SUBJECT: Units 2/3 OFFSITE DOSE CALCULATION MANUAL Revision 26

Enclosed is Revision 26 to the Units 2/3 Offsite Dose Calculation Manual (ODCM). This revision changed all references from a Semiannual Report to a Annual Radioactive Effluent Release Report in accordance with approved PCN-419 and incorporated updates in tables used in the gaseous dose calculations that resulted specifically from the 1992 Land Use Census. Further, major changes were made as a result of an evaluation of the Radiological Environmental Monitoring Program. None of the above changes have any impact on the accuracy or reliability of methods for determining dose or setpoint values.

S023-0DCM
Revision 26
12-20-93

FIGURE 4-5 SONGS 2 & 3 RADIOACTIVE LIQUID WASTE TREATMENT SYSTEMS

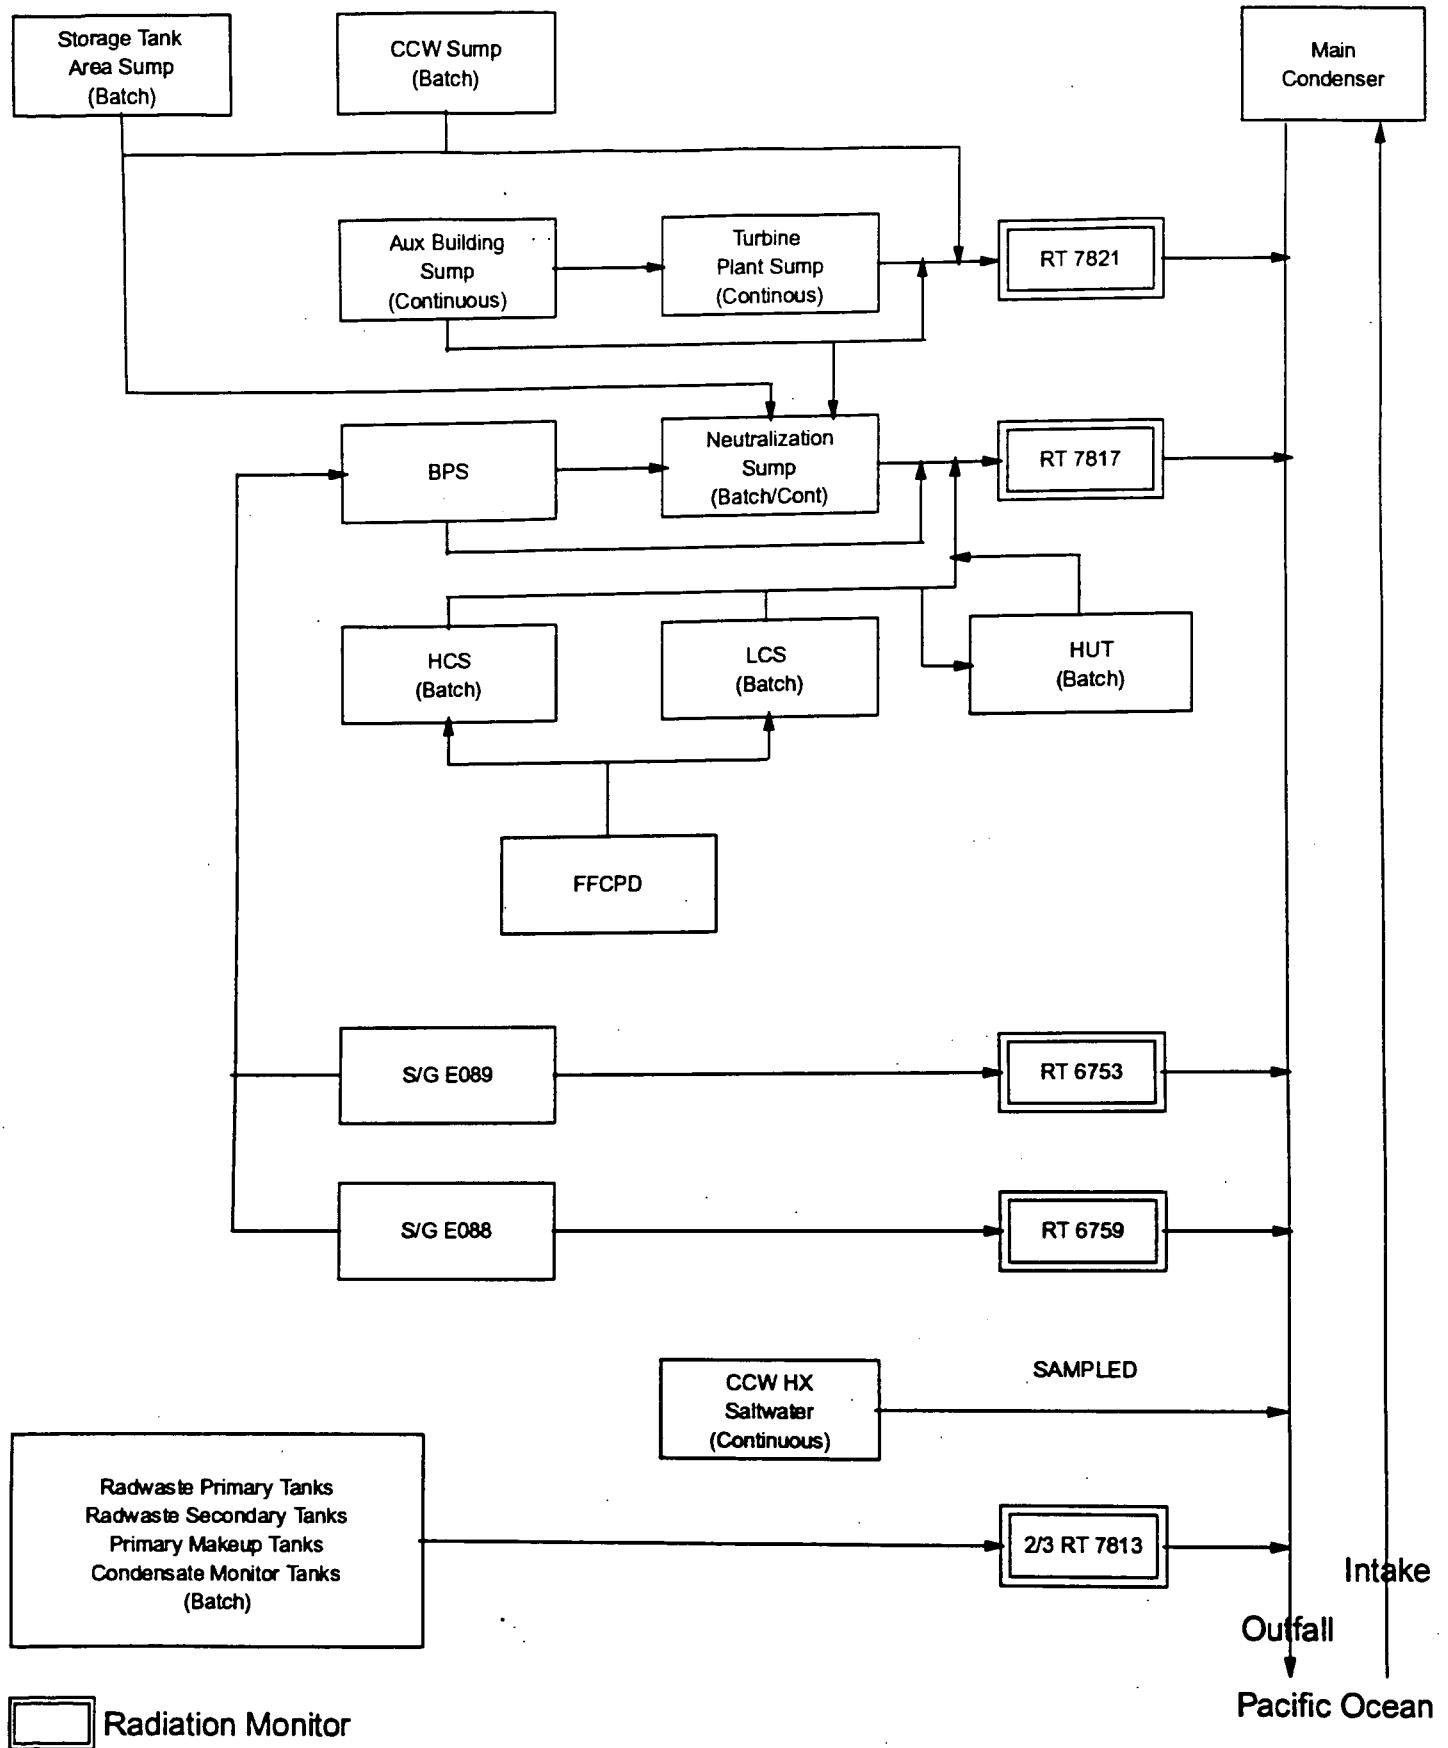
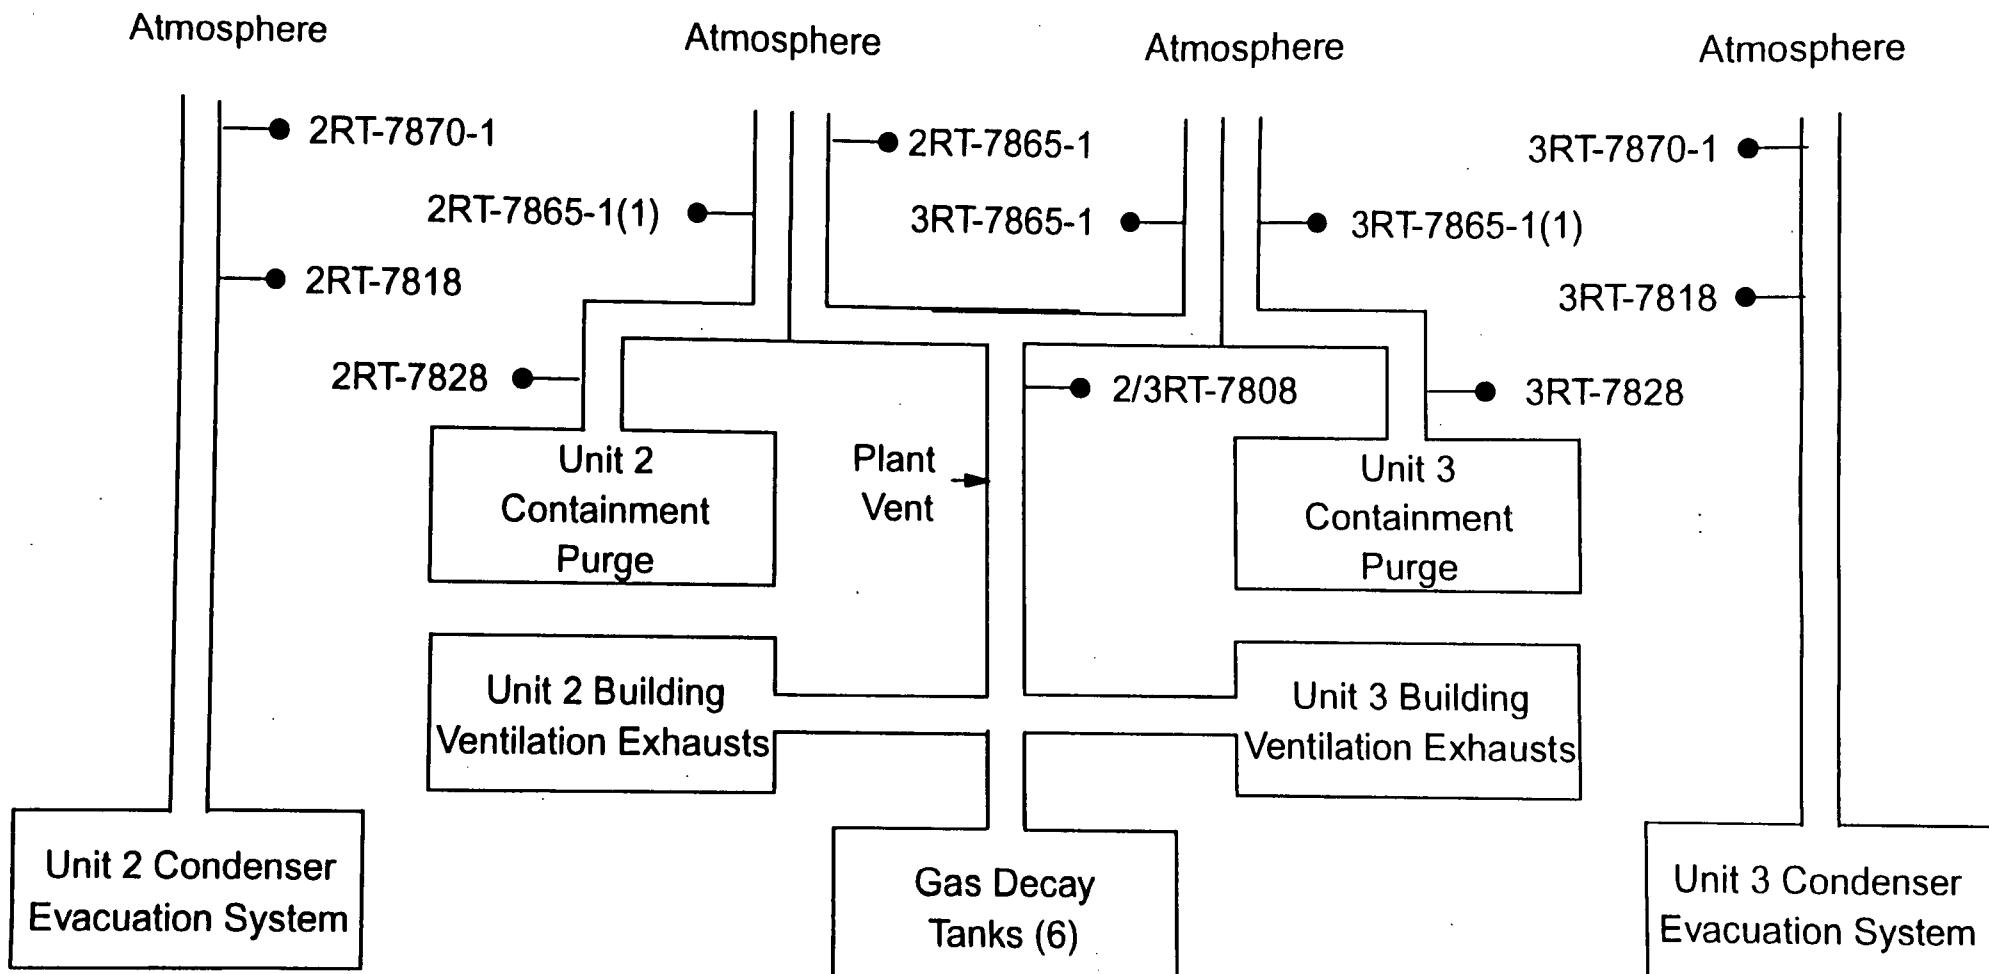
- 4-11^a Corrected typographical error in title of Table 4-4.
- 4-12 Revised the name of NBS to NIST, National Institute of Standards and Technology.
- 4-14 Added FFCPD holdup tank to Figure 4-5.

FIGURE 4-6 SONGS 2 & 3 RADIOACTIVE GASEOUS WASTE TREATMENT SYSTEMS

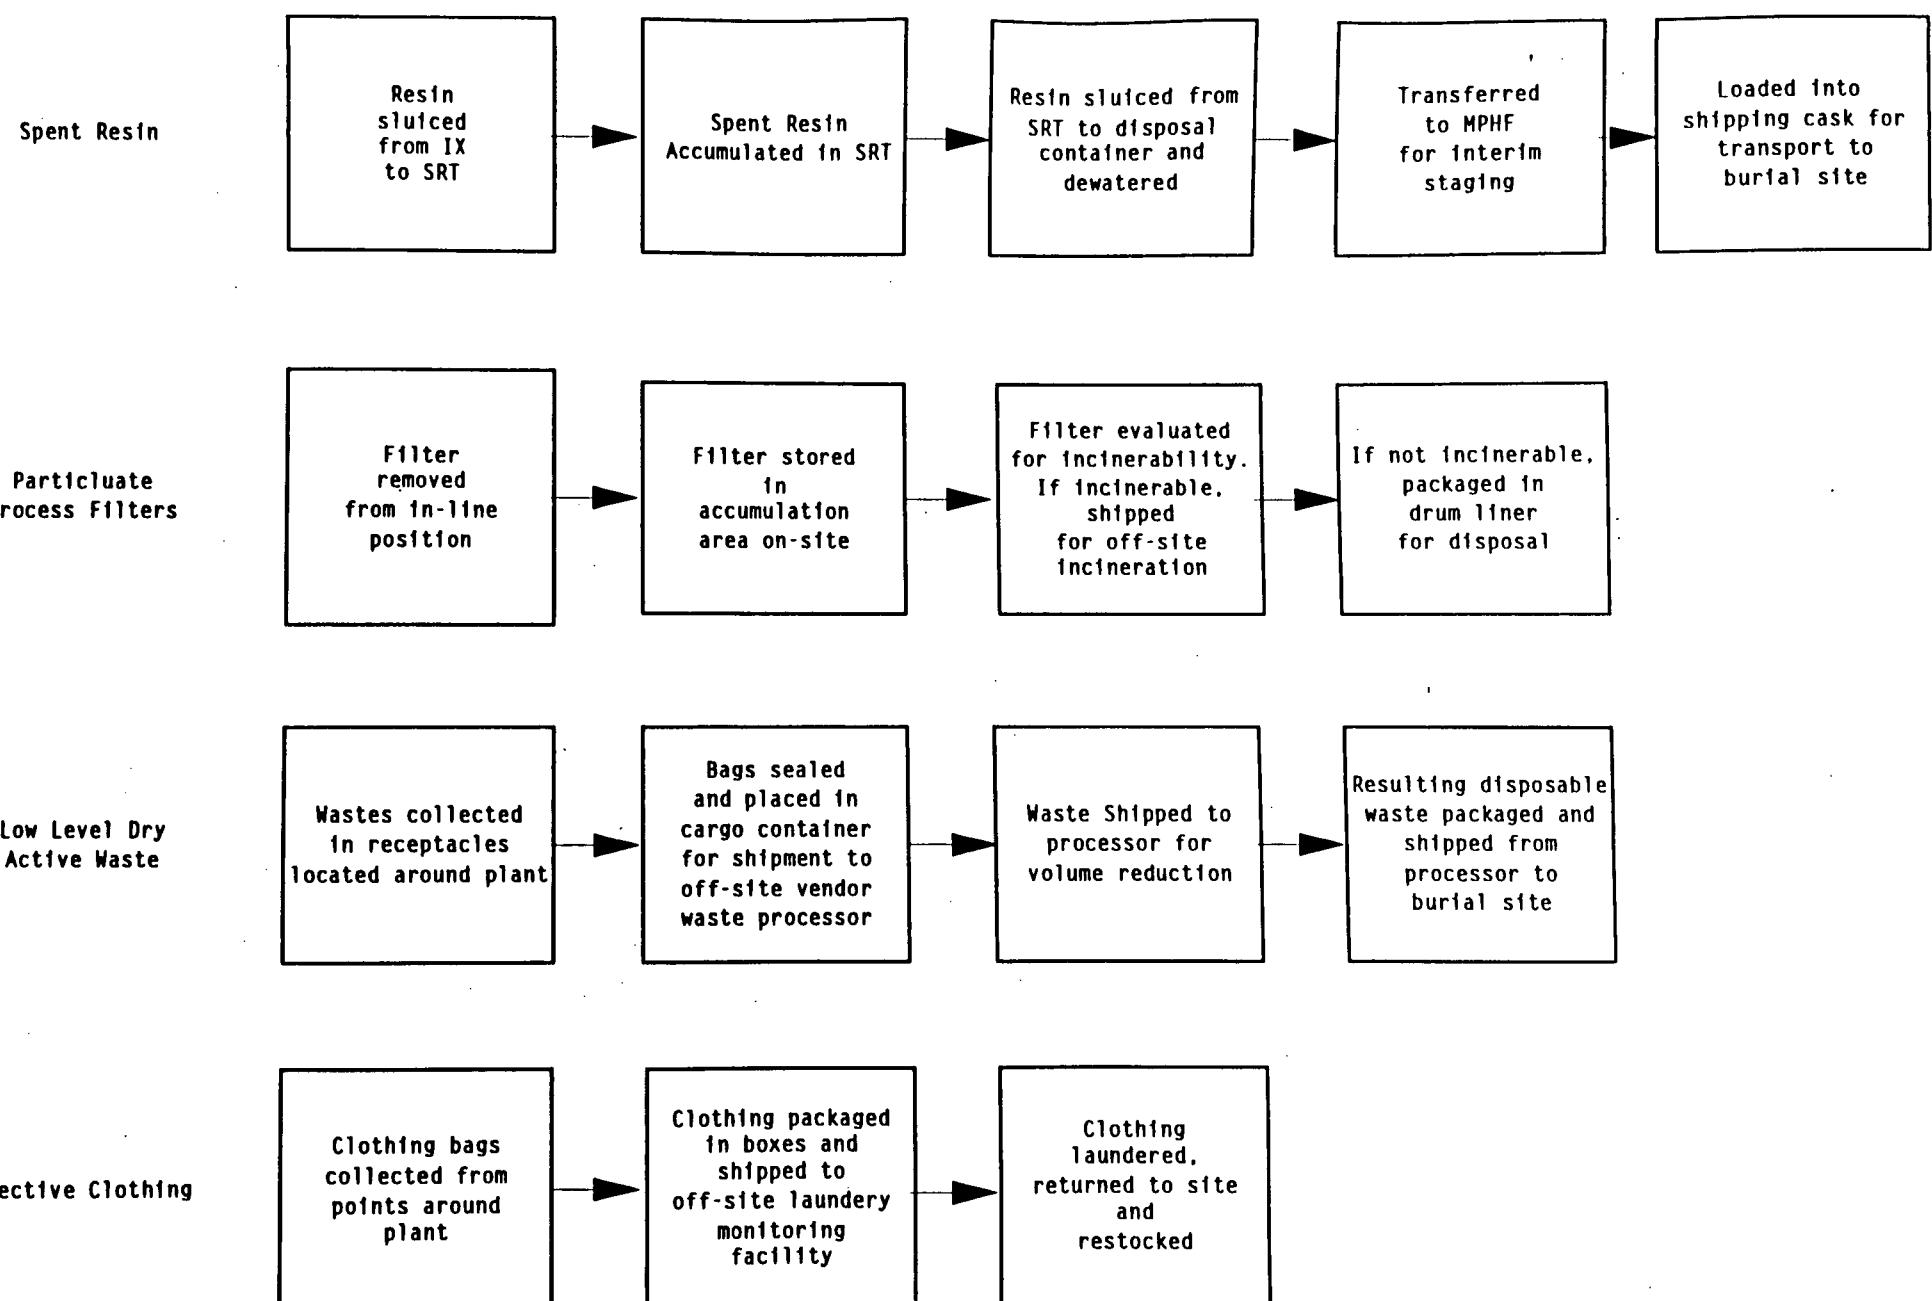
- 4-15^a Figure 4-6 was redrawn with extraneous wording deleted.
- 4-16 Revised Figure 4-7 to reflect current solid waste handling methodology.
- 5-9^a Corrected a typographical error.
